Re: Interpretation for PCA 98-LE-048-3 and FDPA 1998-LE-048-1-3, Metro Park: Building 6
Outdoor Seating and Parking

Re: Interpretation Request – Addition of Outdoor Eating Establishment Seating at Building 6 and Oversized Parking Spaces South of Building 6's Parking Garage
Tax Map 91-1 ((1)) 11B2 and 23E; 91-1 ((28)) 1 and 2A; 91-1 ((31)) 1-4C
PCA 98-LE-048-3 and FDPA 1998-LE-048-1-3 (the "Approvals")

PROFFERED CONDITION AMENDMENT CDPA/FPDA
METRO PARK
(INTERPRETATION EXHIBIT)
LEE DISTRICT
FAIRFAX COUNTY, VIRGINIA

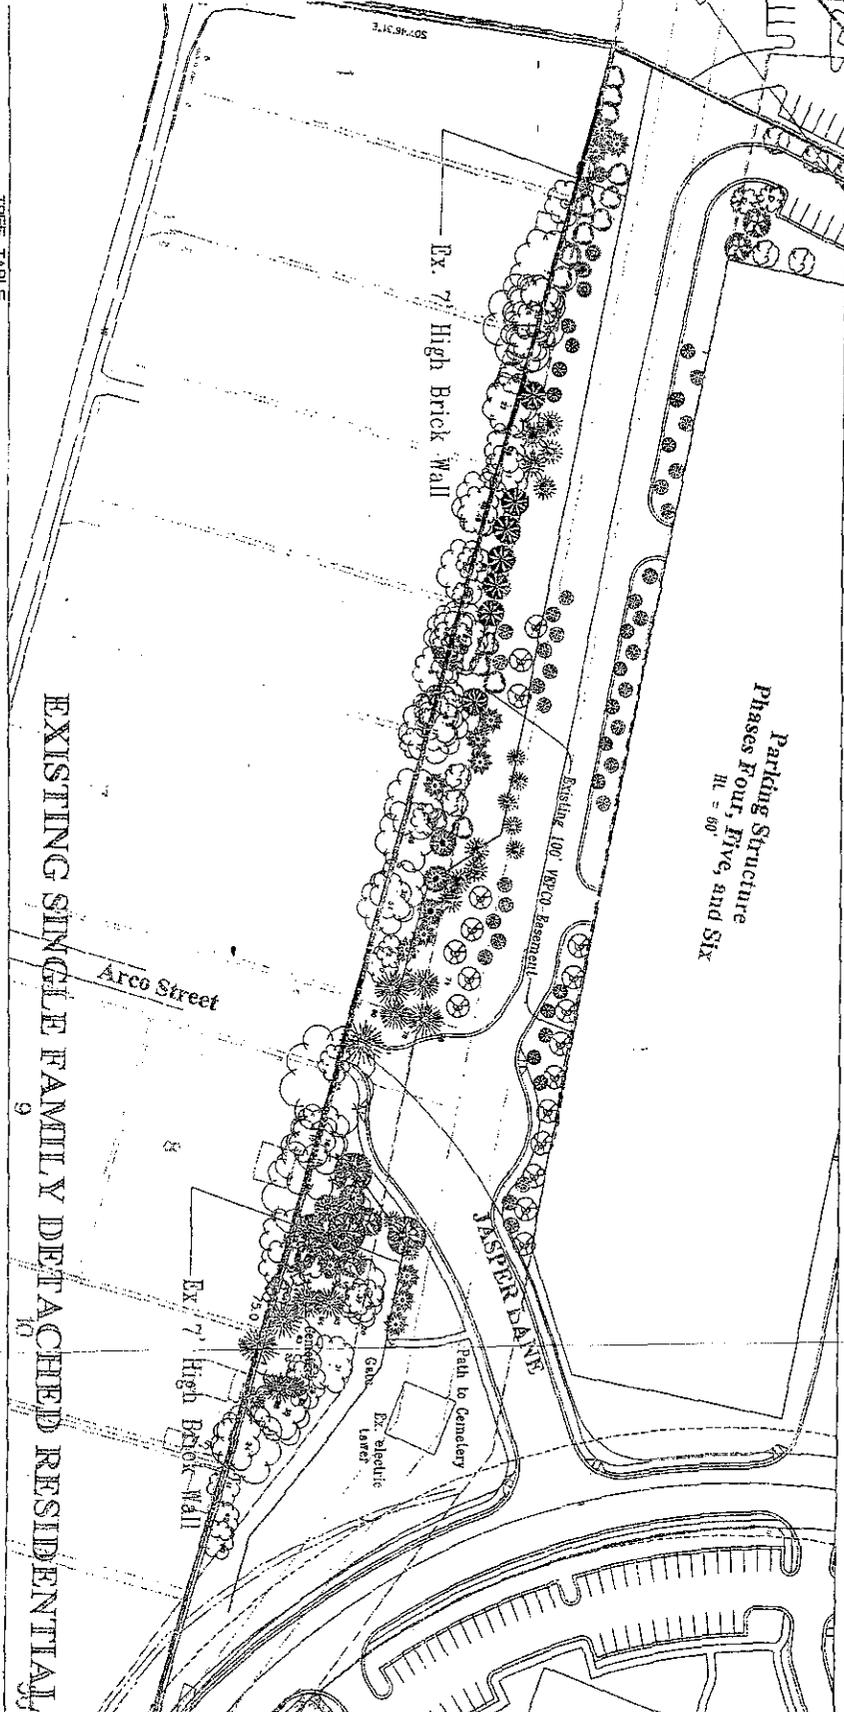
- (1) Exhibit #1 – Interpretation Exhibit, dated 10/04/2011, depicting Sheet 3A of 8 of the approved FDPA which has been modified to show the location of the

previously approved day care play area and generator enclosure depicted in blue and the locations of the currently proposed oversize parking spaces and eating establishment's outdoor seating area depicted in red. Tabulations for parking and open space are also included on this exhibit.

The oversized parking spaces are located in an area that, on the approved FDPA, is shown as a strip of green space planted with 21 generally evenly spaced ornamental trees. This interpretation requests that the 21 ornamental trees continue to be provided, but in a denser formation.

It is submitted that; although the provision of oversized parking spaces will relocate some of the landscaping along the southern face of the garage, these oversized parking spaces are necessary in order to provide legal parking spaces for those vehicles too large to enter the parking garage. It is also submitted that this location is not easily visible from off-site (if at all) due to the provision of full transitional screening and seven foot high barrier. Given these it is submitted that the provision of six oversized parking spaces in this area will not reduce the effectiveness of approved transitional screening, buffering, landscaping or open space.

It is my determination that the addition of an outdoor seating area as described above and shown in the submitted exhibits, is in substantial conformance with the proffer and the CDPA/FDPA, provided that adequate parking is demonstrated to the Department of Public Works and Environmental Services (DPWES) to be available to meet Zoning Ordinance requirements and all proffered limitations and requirements are met.

As such, it is my determination that the proposed six oversized surface parking spaces along the southern side of the central parking garage (garage for Buildings 4, 5 and 6) would be in substantial conformance with the proffers and the CDPA/FDPA, provided that these parking spaces will not be constructed until the outdoor play area southwest of Building 6 is established. Any plant materials which fail to survive the transplantation/relocation, or construction activities required to install pavement for the oversized parking, must be replaced, subject to Urban Forest Management (UFM) approval.

RESTAURANT OUTDOOR SEATING AREA
 (INTERPRETATION EXHIBIT)
 Metro Park 6

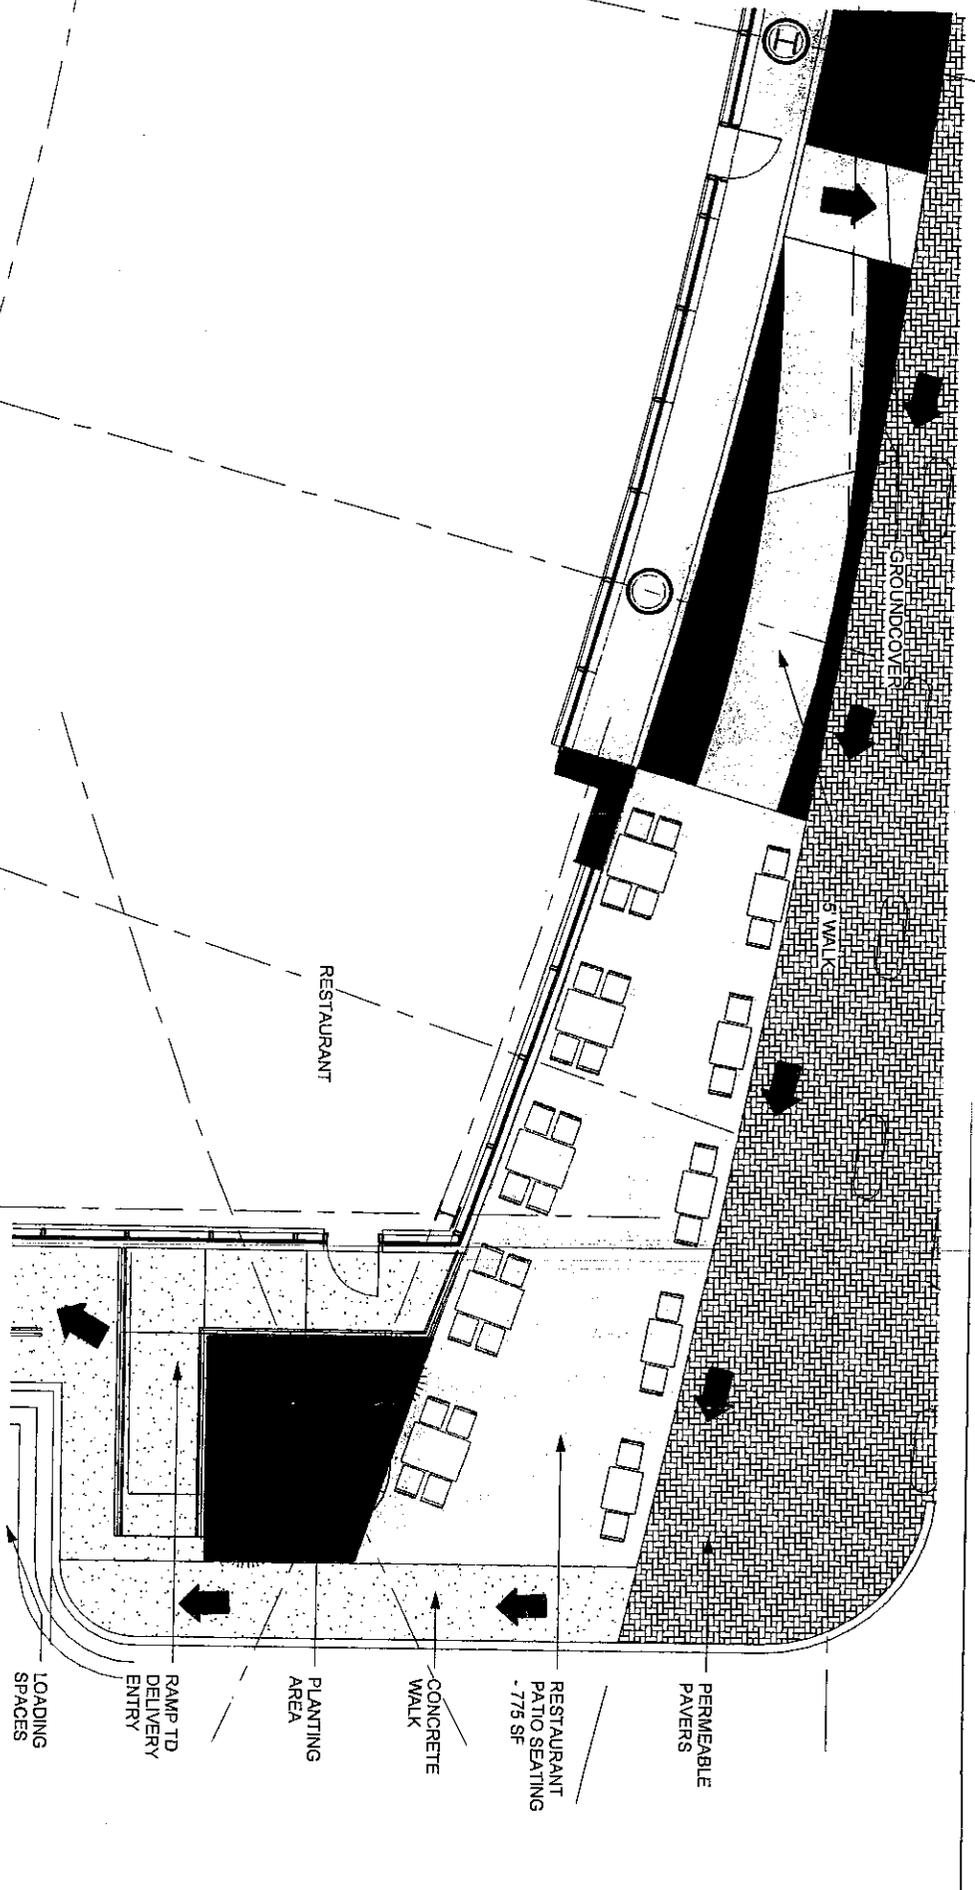
Answer: The outdoor seating is located in an area that, on the approved FDPA, does not include any landscaping, buffering or transitional screening. It is open space only in the sense that this area is shown as part of a wide walkway around the building. A walkway will continue to be provided around the building, adequate open space will continue to be provided and the amount of landscaping actually increases in this area; therefore, the provision of outdoor seating in this area will not reduce the effectiveness of approved transitional screening, buffering, landscaping or open space.

ON OF THE PATIO AND PLANTINGS TO BE DETERMINED PRIOR TO THE SITE PLAN REVISION
